**Project #16-014
Standard Plumbing
Located at 1860 South 1000 West**

Project Name: Standard Plumbing
Proponent / Owner: Brandon Dawson / Richard N Reese Family LLC
Project Address: 1860 South 1000 West
Request: Conditional Use & Design Review Permit
Current Zoning: Gateway (GW)
Type of Action: Quasi-Judicial
Hearing Date: March 24, 2016
Submitted By: Russ Holley, Senior Planner

RECOMMENDATION

sheet:
a2.0

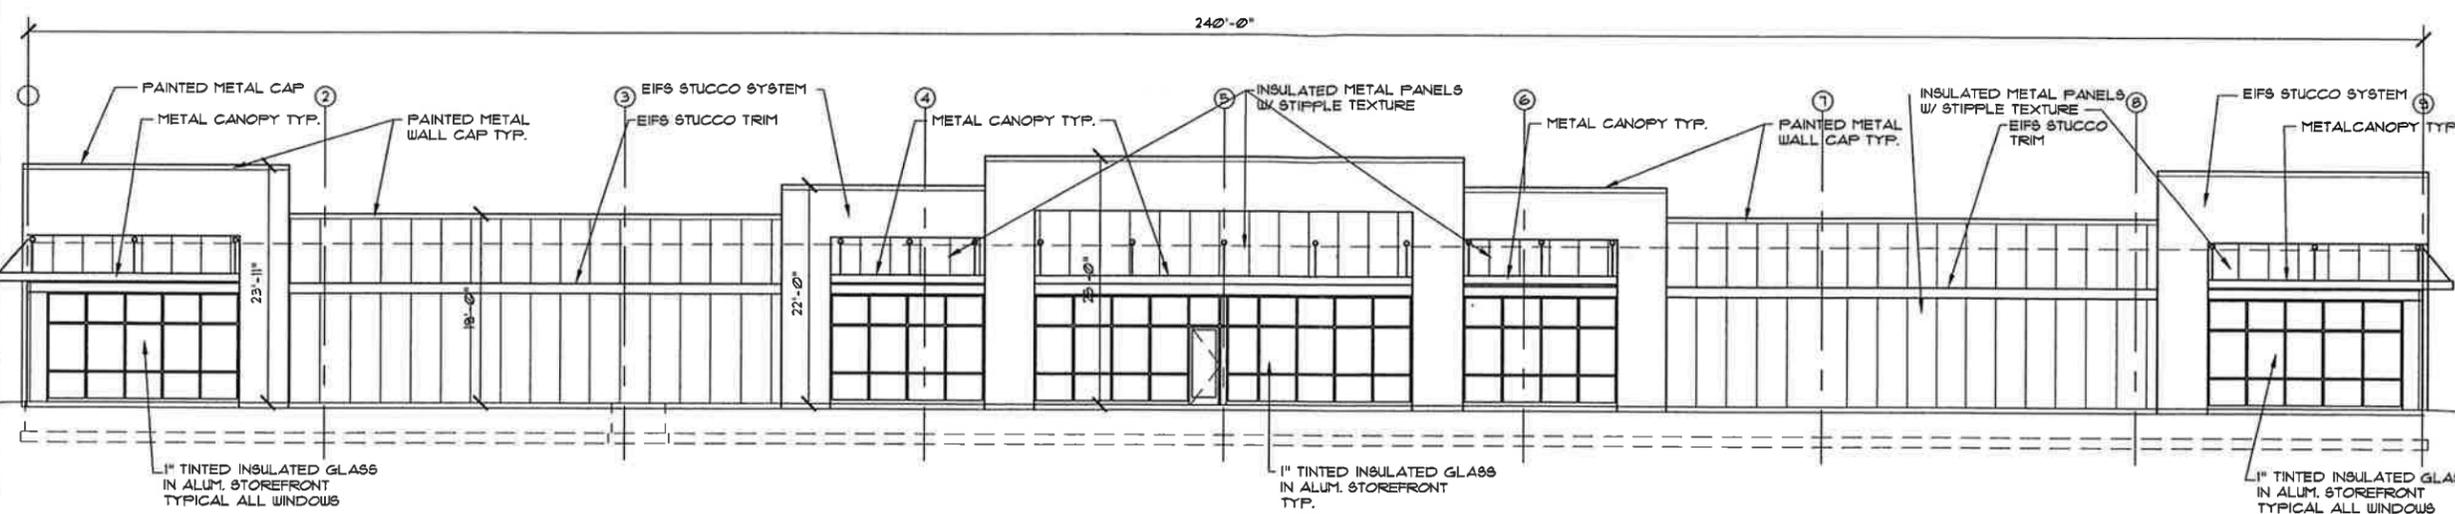
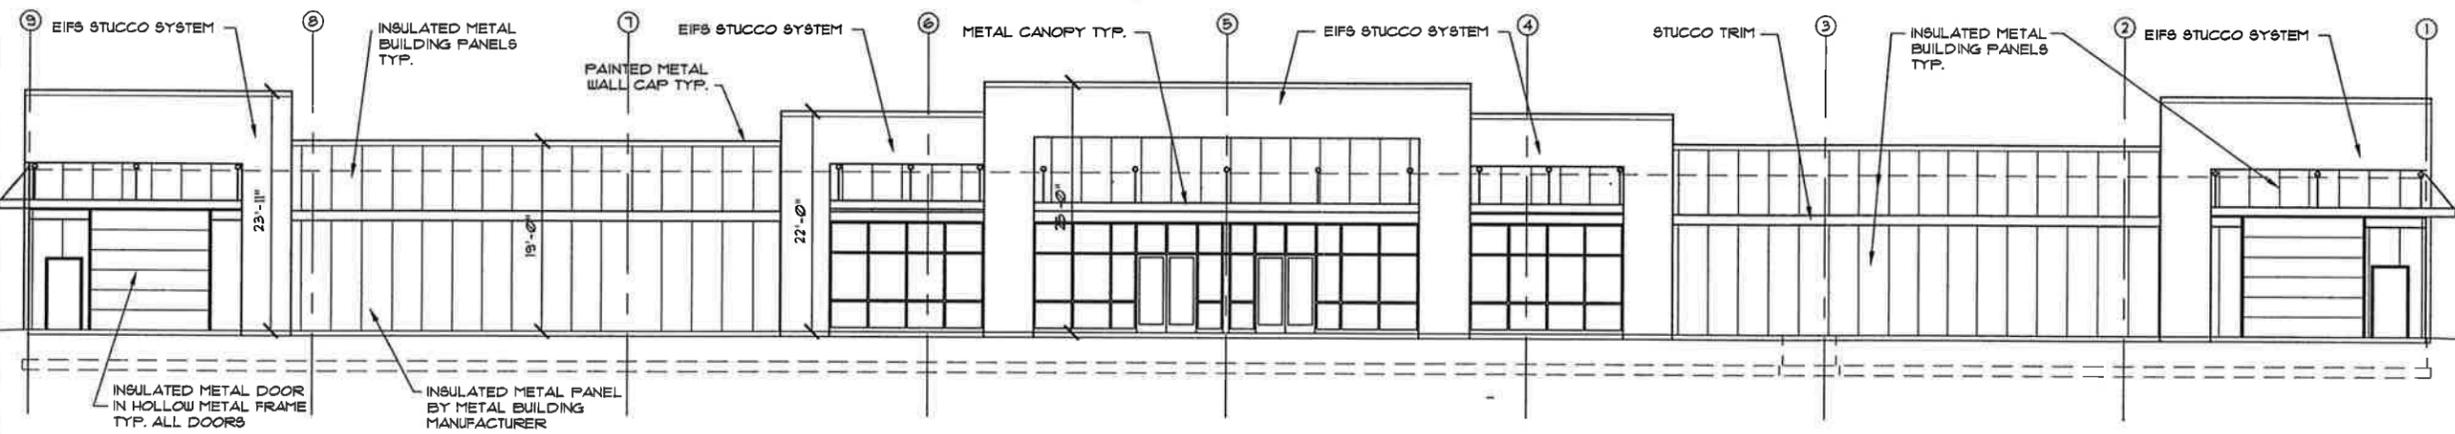
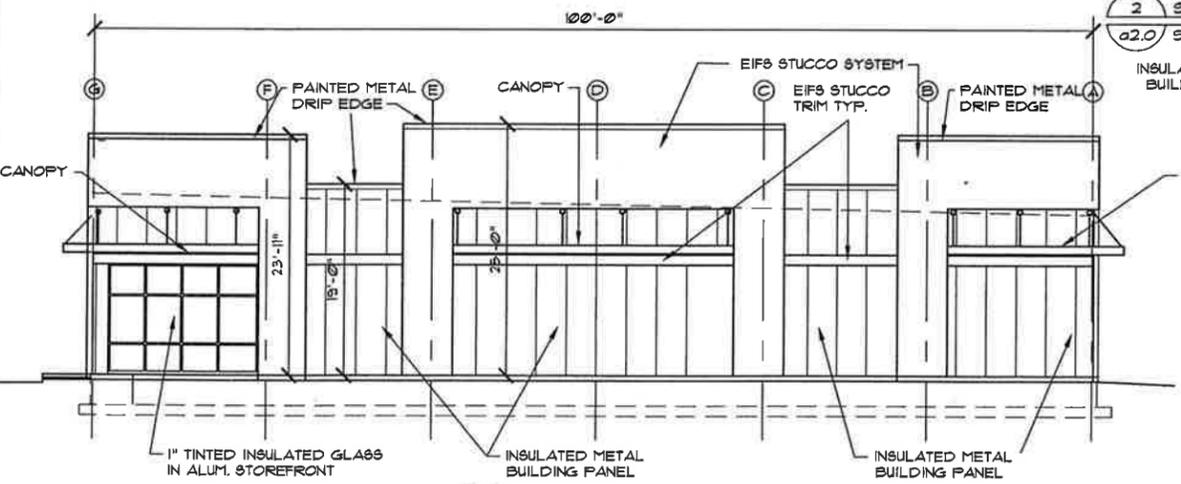
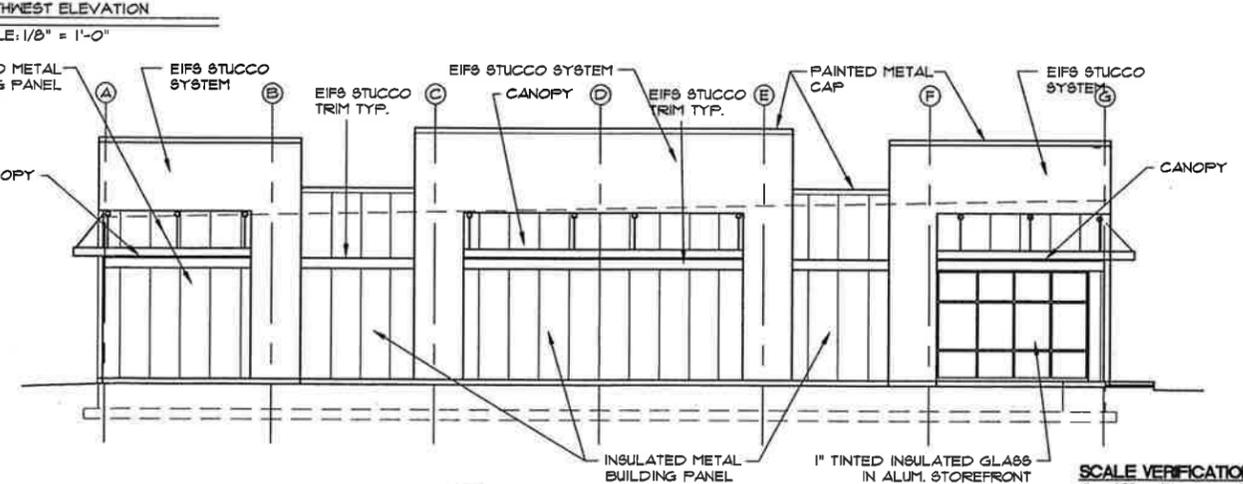
The LDC 17.19.100 requires the building to be oriented to the street with a functioning pedestrian entrance and at least 30% glass on the ground floor street-facing facade. Blank walls over 30' in length are prohibited without an architecture treatment or feature. Entrances are required to have weather protection above.

The building fronts along HWY 89/91 with a doorway located at the center. The façade is a combination of stucco and metal vertical siding in brownish earth-tone colors. The street facing façade has approximately 27% glass with a large centered bank of storefront windows along with two large window openings at the corners. A metal horizontal awning provides weather protection above doorways on all sides. The center street-facing wall sections total approximately 48' in length. A small horizontal band is placed on these center wall sections to meet minimum wall break requirements. As conditioned with additional glass on the street facing facade, the project meets the requirements of the LDC.

3. Plant a minimum of eight (8) trees along the two residential borders to the north and east of the proposed development.
4. Increase the HWY facing facades glass transparency to the required 30%. On the two side facades visible from the public right-of-way, use clusters of evergreen trees and plantings to help break-up blank areas of wall.
